**INFRASTRUCTURE AND ENGINEERING SERVICES DEPARTMENT
INFRASTRUCTURE PLANNING AND DEVELOPMENT ENGINEERING**

MEMO TO: Giuseppe Russo, Planner II

FROM: Paul Guerreiro, Manager of Engineering - Site Plans and Site Alterations

SUBJECT: ZBLA-25-0001 (Zoning By-Law Amendment)
OPA-25-0001(Official Plan)
Insire Estates
11 Harris Avenue

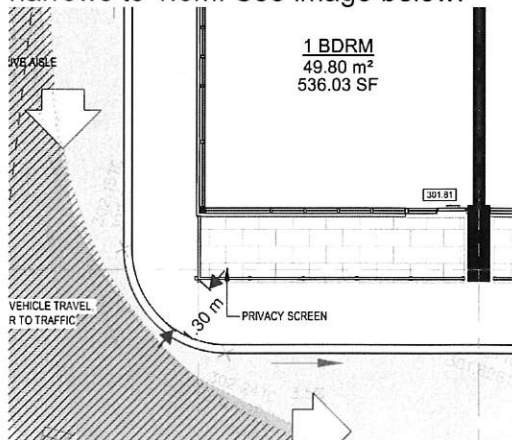
- ☐ The arrows demonstrating direction of travel appear to be reversed.
- ☐ Please ensure that the proposed pick-up / drop-off area facilitates and demonstrates vehicle travel along the right-side of the road and minimizes conflicts.
- ☐ Demonstrate all vehicle maneuvers entering and exiting the proposed site access making a right-in / right-out as this is most critical maneuver.
- ☐ The egress maneuver for the Fire truck is incomplete. Please demonstrate the fire truck making the full maneuver to exit the site. If reversal is required, the fire truck may not reverse more than 90 metres.
- ☐ Please ensure that a 1.5m sidewalk is provided throughout the entirety of the pedestrian walkway. Currently at the southwest corner of the building the sidewalk narrows to 1.3m. See image below.
